Browns Ferry Nuclear Plant, Unit 2
Renewed Facility Operating License No. DPR-52
NRC Docket No. 50-260

Subject: **Response to Request for Additional Information Regarding Relief Request 2-ISI-28 (TAC NO. ME8779)**

TVA Response to NRC Request for Information

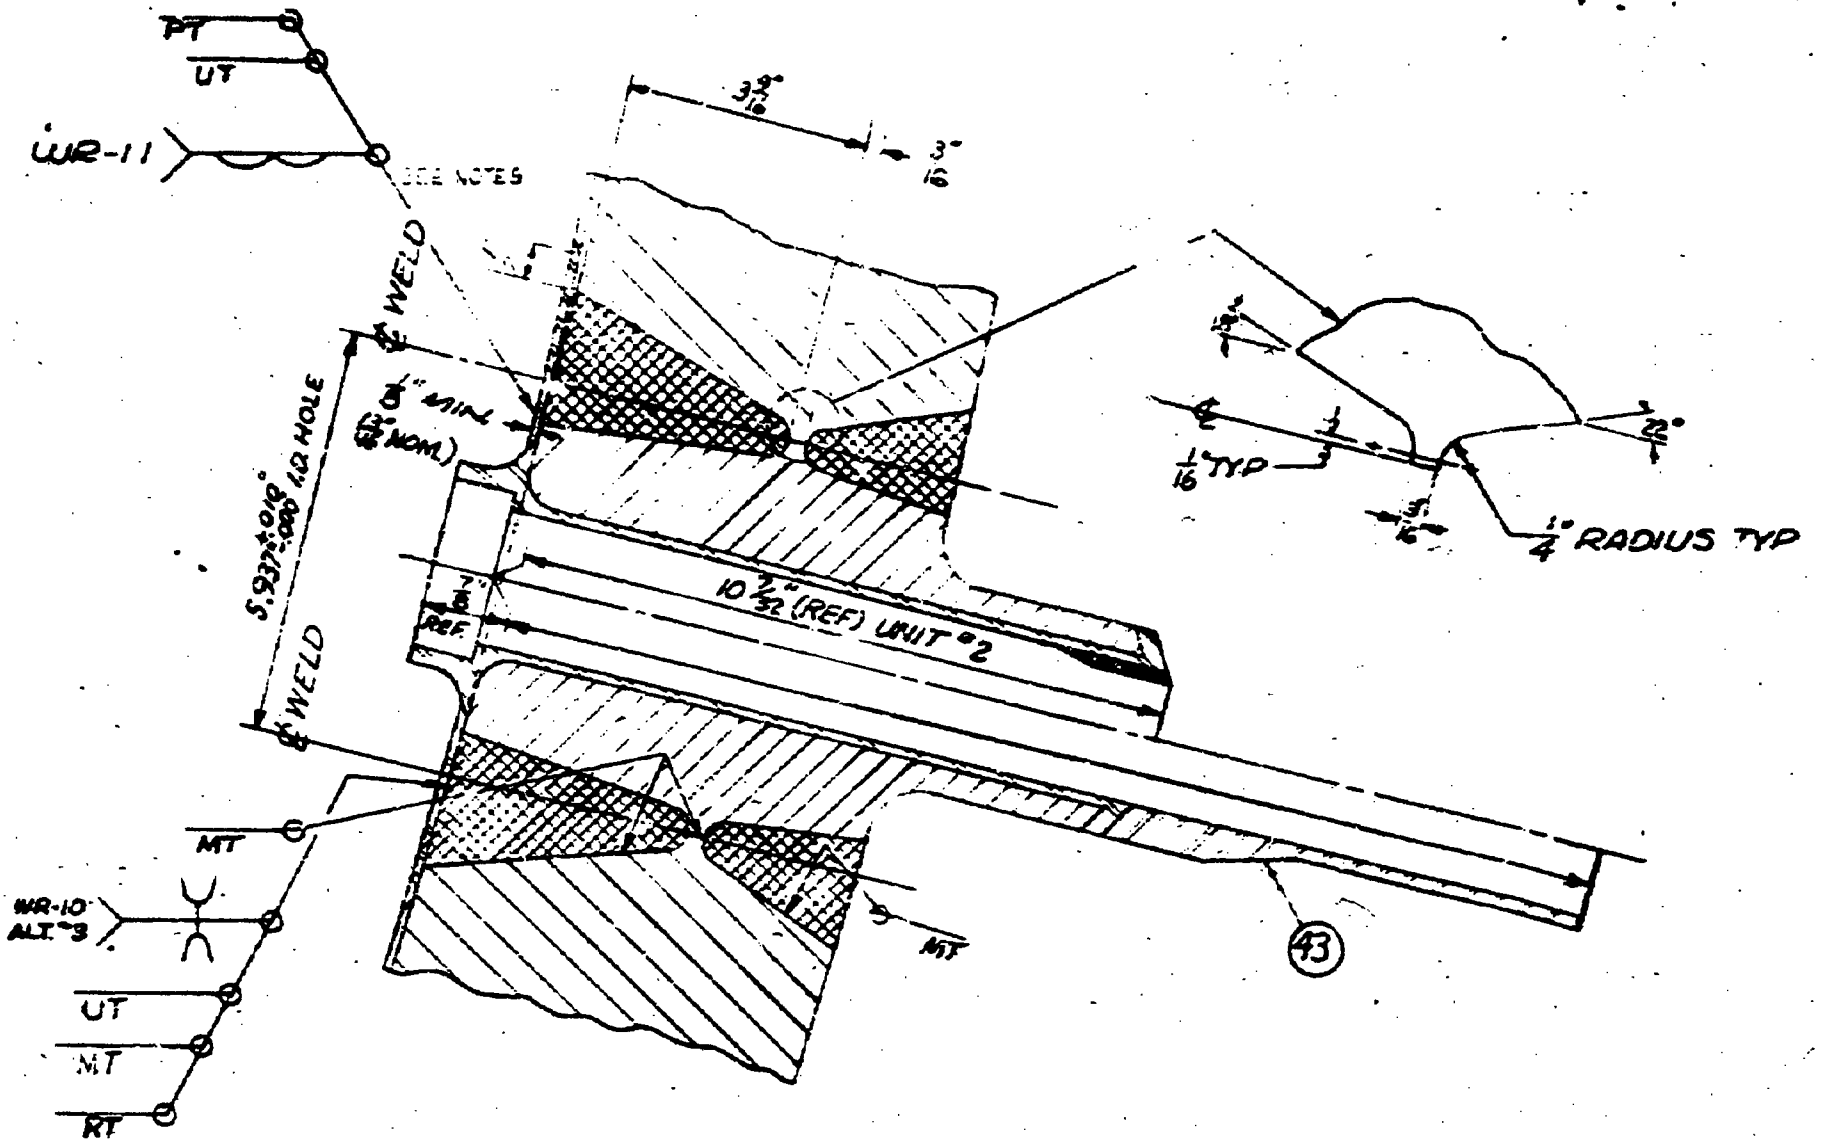
For Weld N10-NV, the calculation for circumferential ultrasonic examination coverage gives a higher weight to the lower 15 percent than the upper 85 percent. From the CDSs, it appears that the Composite Axial plus Circumferential Coverage is 81.7 percent, not 86.2 percent. Confirm that the Composite Axial plus Circumferential Coverage is 86.2 percent. If not, address the discrepancy.

The correct value of the Composite Axial plus Circumferential Coverage is 81.7 percent. The calculation in the examination report determined the percentage of coverage obtained. But, during calculation of the circumferential coverage of the upper 85% of thickness (T), the calculation did not include the appropriate weighting factor of 85% (0.85). The value should have been multiplied by 85% (0.85) prior to composite. This error has been entered into TVA's Corrective Action Program.

Detail B, Drawing 151863E, Modification of 2" Liquid Control Nozzle

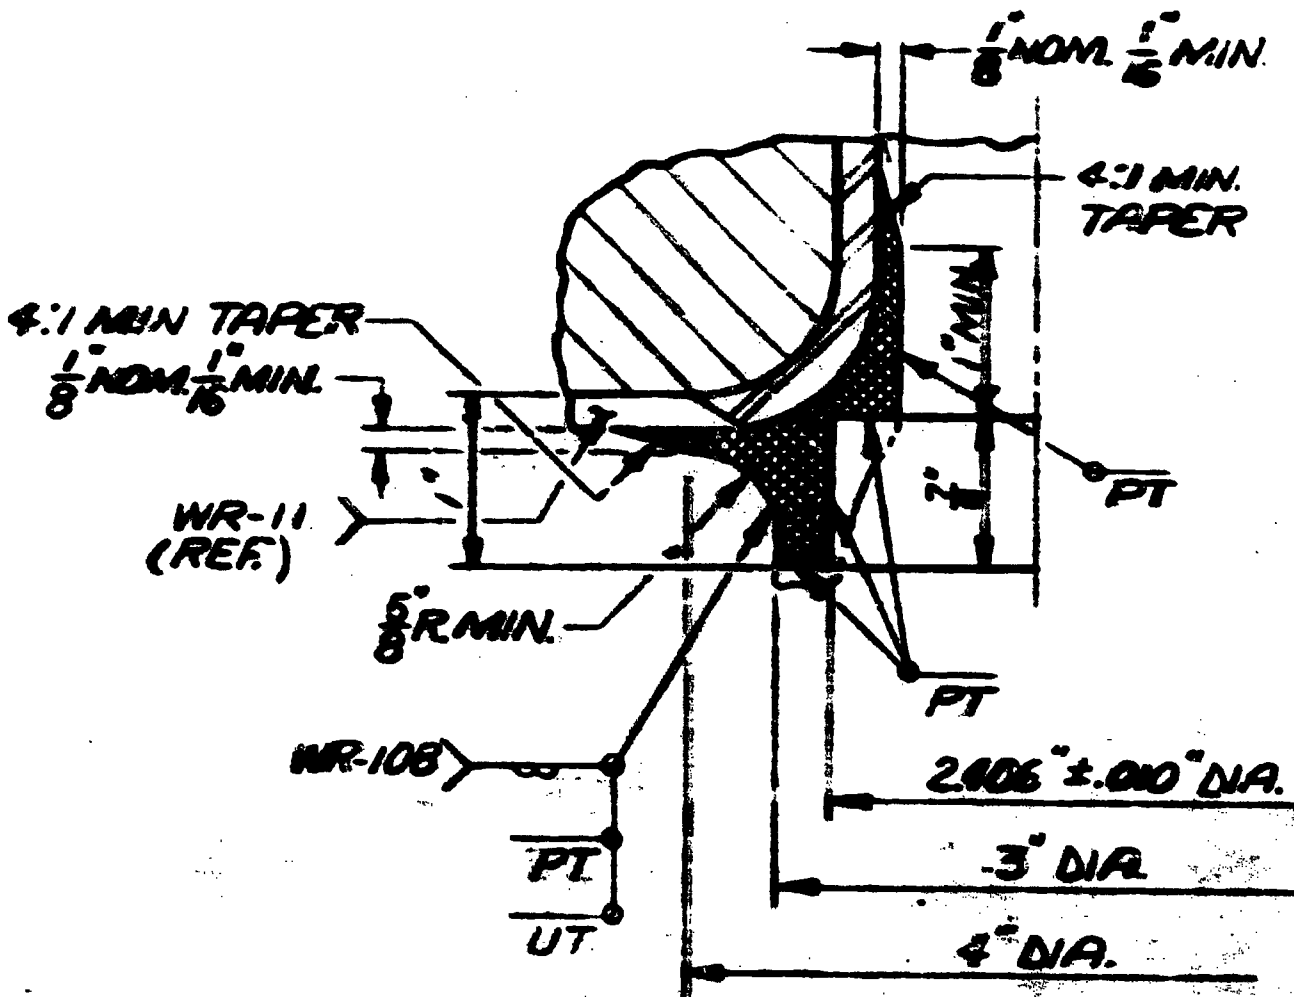
Identify the American Society of Mechanical Engineers material designation for each part of each weld. If a material is clad with Stainless Steel or other metal, clearly identify that material.

Request for Relief 2-ISI-28 requests relief from weld examination coverage requirements for one reactor pressure vessel nozzle-to-vessel full penetration weld and nozzle inside radius section. Attachment 1 shows the nozzle to vessel weld (N10-NV), including the requested weld symbols. A built up pad machined to form a socket for connection of Standby Liquid Control (SLC) piping is present on the inner radius of the nozzle forging. Details of the inner radius configuration are provided in Attachment 2.

The SLC nozzle is located in the lower head upper segment of the bottom head assembly. The SLC nozzle forging is fabricated from ASTM A 508, Class 2 manganese-molybdenum steel conforming to ASME Code Case 1332-2 and welded to the lower head using E9016-G. The lower head upper segment is clad with E309L.

Figure 4. Browns Ferry Standby Liquid Control Nozzle (N10): Probe Scan Limits and Examination Coverage for Vessel Shell Detection Technique, 70/(2 to 23)v.

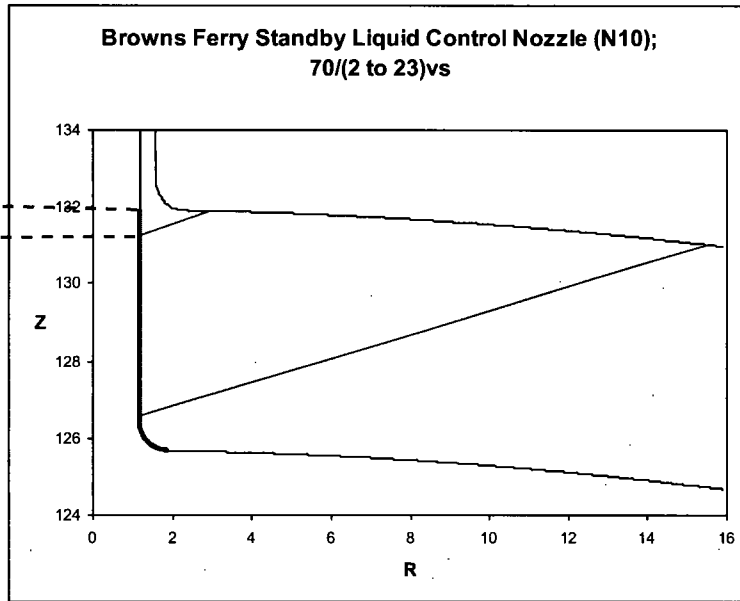
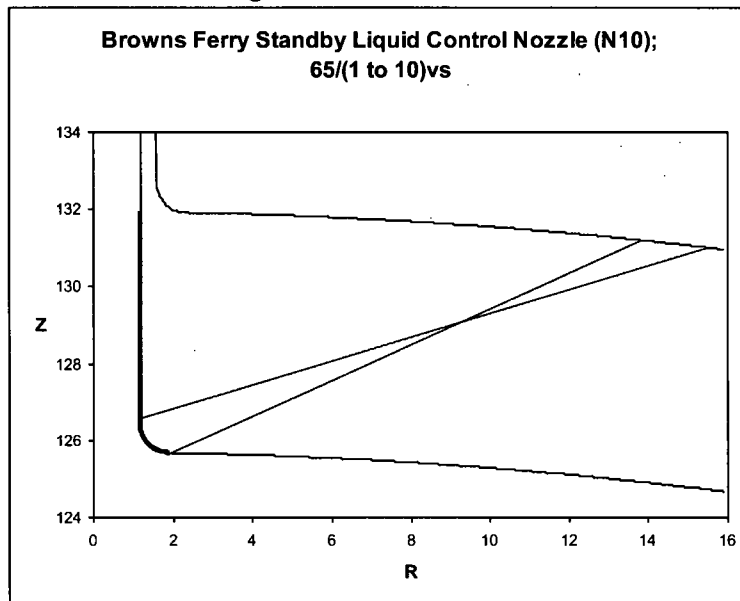
Address how the coverage for the N10-IR inner radius examination was calculated. Provide a coverage map showing the areas that were missed.

Modeling report IR-2004-43 was developed by the EPRI NDE Center. The essential geometric parameters of the Browns Ferry Standby Liquid Control nozzle and the qualified procedure essential variables were input into the EPRI software to calculate the coverage obtained. Attachment 3 provides the coverage map for the limited volume of coverage.

Figure 4 shows the minimum and maximum probe radial positions and the portion of the examination volume covered by the vessel shell detection technique, 70/(2 to 23)v, for probes scanned at the azimuth angle of 0°.

The bold line area between the dotted lines represents the non inspected area.

Figure 5 shows the minimum and maximum probe radial positions and the portion of the examination volume covered by the vessel shell detection technique, 65/(1 to 10)v, for probes scanned at the azimuth angle of 0°.
